SUBJECT: SEP SAFETY TOPICS III-6, SEISMIC DESIGN CONSIDERATION  
AND III-11, COMPONENT INTEGRITY - OYSTER CREEK  
NUCLEAR GENERATING STATION

SEP SAFETY TOPIC EVALUATION  
OYSTER CREEK NUCLEAR POWER PLANT

TOPICS: III-6, SEISMIC DESIGN CONSIDERATION  
III-11, COMPONENT INTEGRITY

FIGURE 1

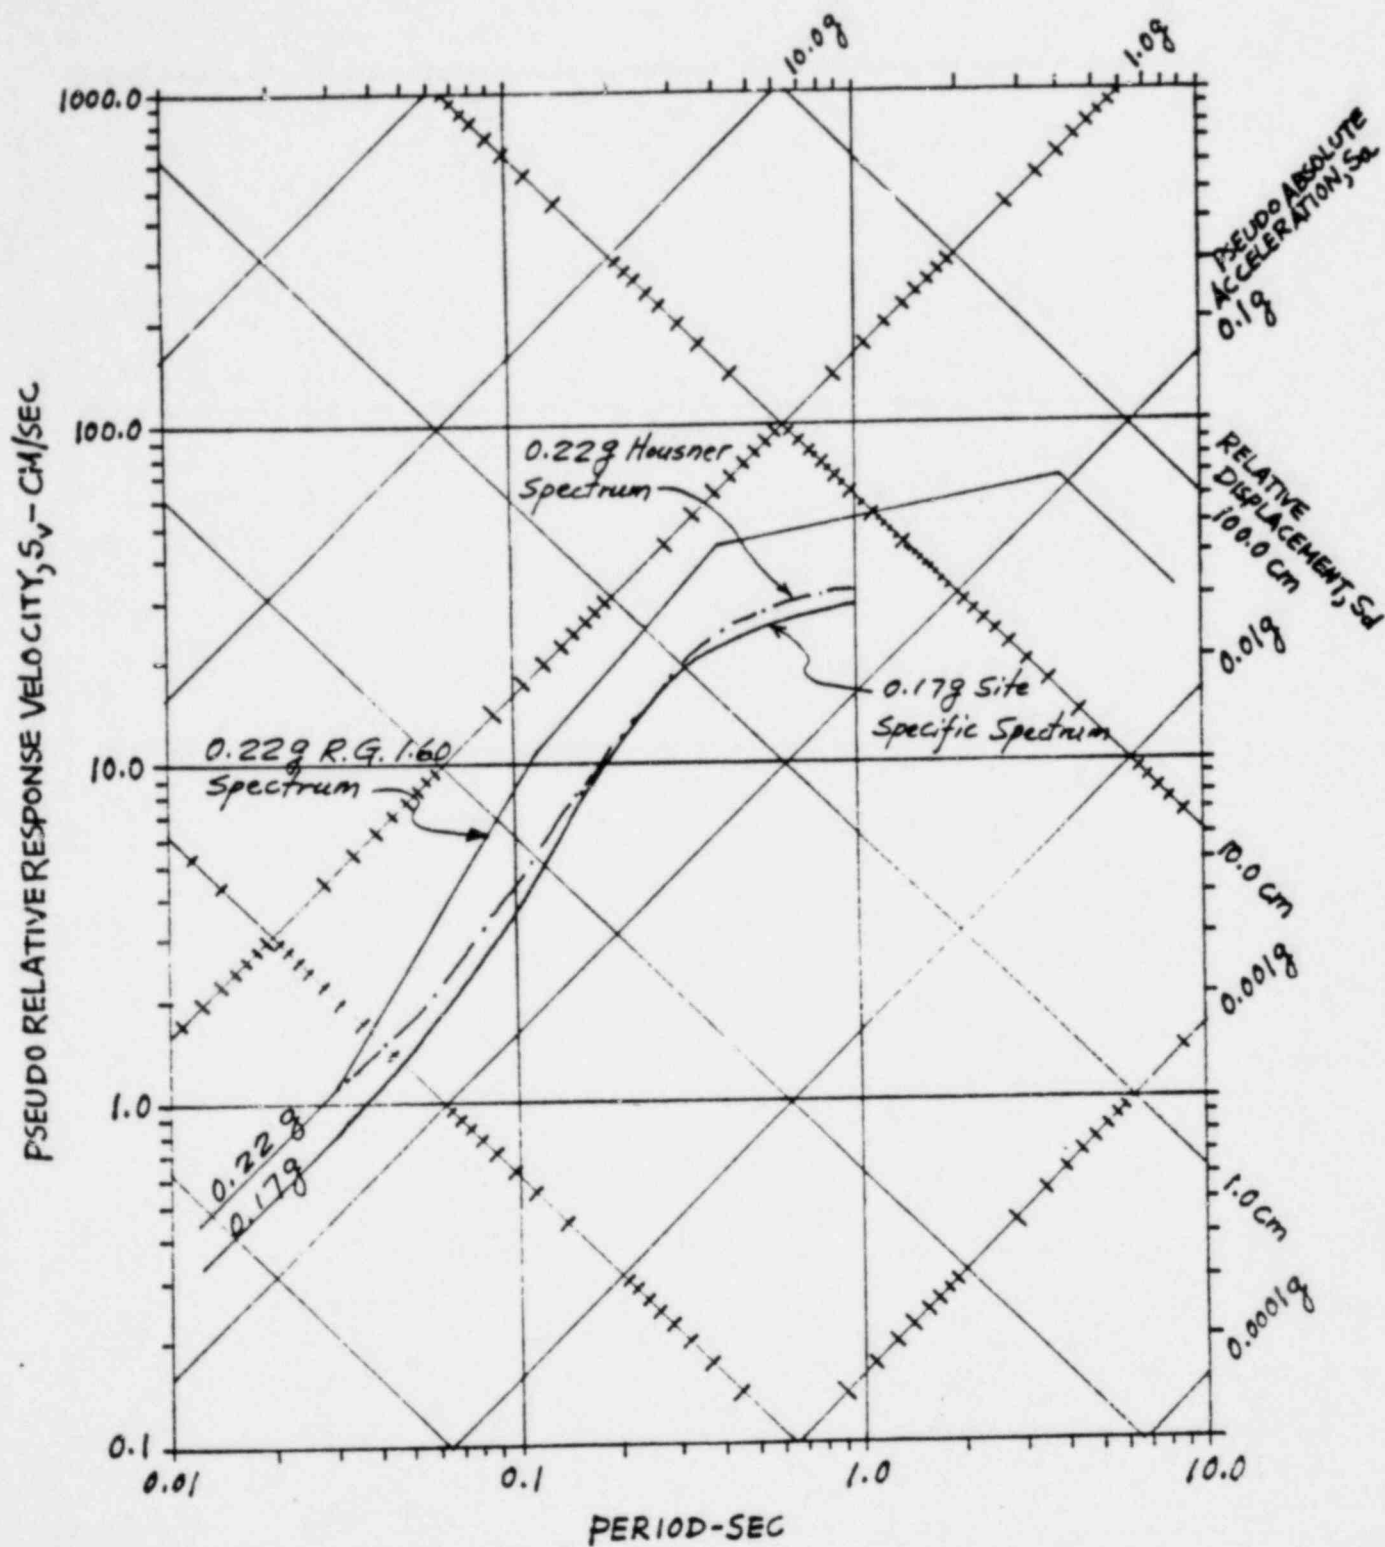
Recently, the site specific spectra development program was completed, and the spectrum developed for the Oyster Creek site was issued to the licensee on June 17, 1981 (Ref. 2) for any future work that may be required. The basis for the development of site specific spectra was documented in NRC NUREG/CR-1582 Report, "Seismic Hazard Analysis," (Ref. 3). This site specific spectrum is appropriate for assessing the actual safety margins present for any structures, systems and components that have been identified as open items. In Figure 1, a comparison is made for the ground response spectra that were used for the original plant design and for SEP seismic reevaluation (Reg. Guide 1.60 spectrum and the site specific spectrum).

Furthermore, since the ground response spectrum (0.2g R. G. 1.60 spectrum) used for Oyster Creek seismic reevaluation envelopes the Oyster Creek site specific ground response spectrum, additional safety margins in the structures, systems and components do exist for resisting seismic loadings. Thus, the staff concludes that the Oyster Creek plant can continue to operate with reasonable assurance that the operation of the facility will not be inimical to the health and safety of the public until a resolution is reached for the items identified.
